SERVICE BULLETIN

Ref: SRV-023-001

Product: AirFlex and Grain Belt Headers on Claas Combines

Figure 3

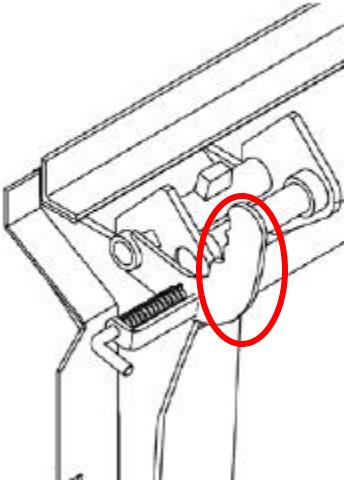
The portion of the latch that contacts the shields needs to be removed so it cannot damage the shields. Figure 3

Figure 4

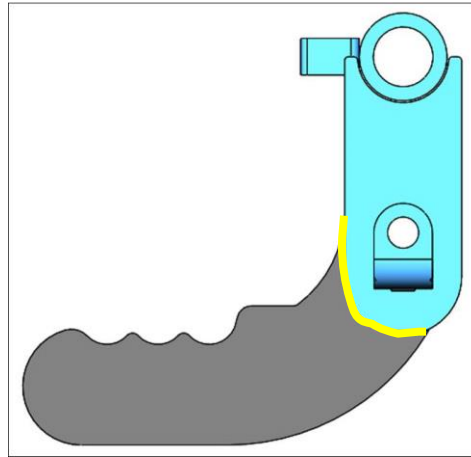
A saw or cut off wheel can be use to take the end of the latch off. Remove the entire handle and grind smooth any rough edges. Figure 4
